## **SAFETY ALERT – JUNE, 2026**

C75-W-6-10 Pitot Tube

All CH aircraft models using the C75-W-6-10 Pitot Tube  
Typically the STOL CH750 and CRUZER CH750

**VISUAL REFERENCE – CORRECT vs. NOT CORRECT CONFIGURATION**

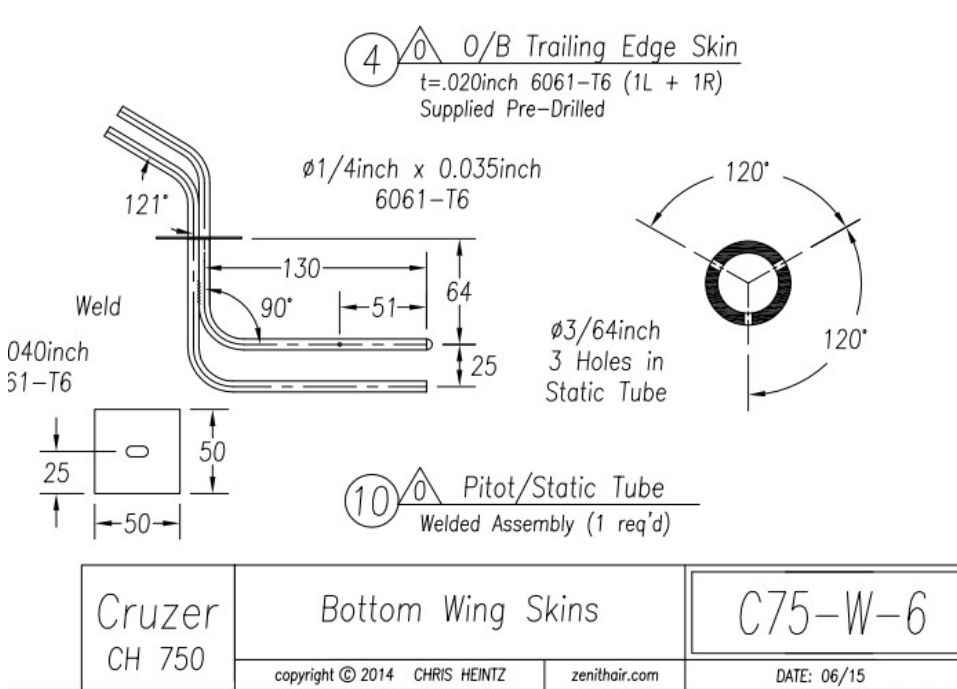
C75-W-6-10 Pitot Tube may not be the correct type for your aircraft.

Inspect your Pitot Tube as per the following drawing. If it does not match drawing C75-W-6, with the open tube on the bottom, It is suggested that you contact Zenith Aircraft for the latest version.

Compare your installed Pitot/Static tube to the photos and engineering drawing below. The correct assembly matches **drawing C75-W-6** (welded Pitot/Static tube assembly with specific tube routing and dimensions shown).

**Above – Correct**

**Above – NOT Correct**

**After changing or when installing your pitot static system. Regardless of where you purchased it, the system needs to be tested for leaks and flight tested / calibrated.**
